JOIST / BEAM ARRANGEMENT DIAGRAMMATIC: issued layout, spacing, sizes and reactions pending.

REVISION DELTA / ADD-01.2

ADDENDUM / PACKAGE BOUNDARY

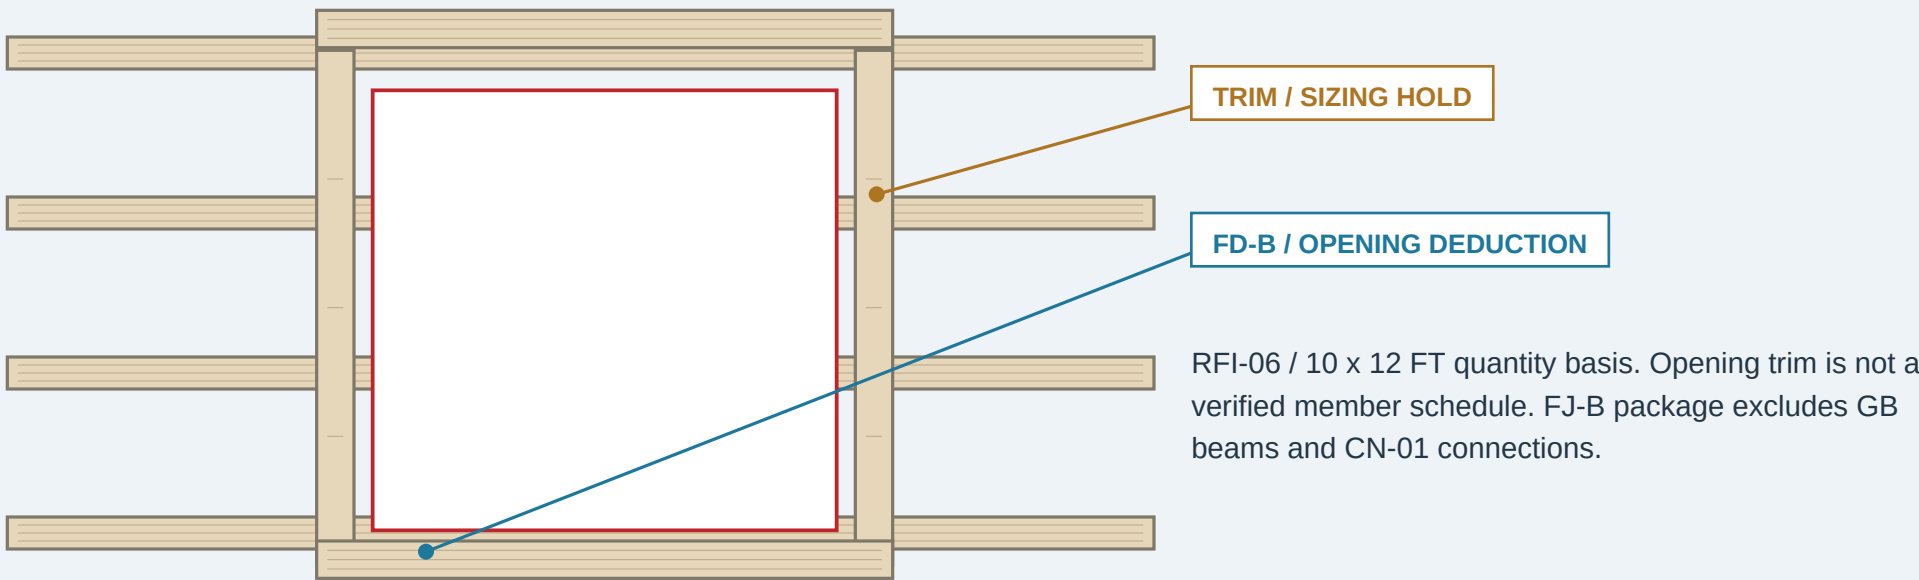
310 panels -> 304 panels

Deck purchase decreases six panels. RT-01 truss procurement remains at 9,000 SF. PB-01 permanent bracing remains 960 LF net; design layout and price are pending.

RFI-03: permanent bracing excluded from truss input. Confirm curb locations, trimming and support. Supplier freight, crane access, release sequence and quote validity require confirmation.
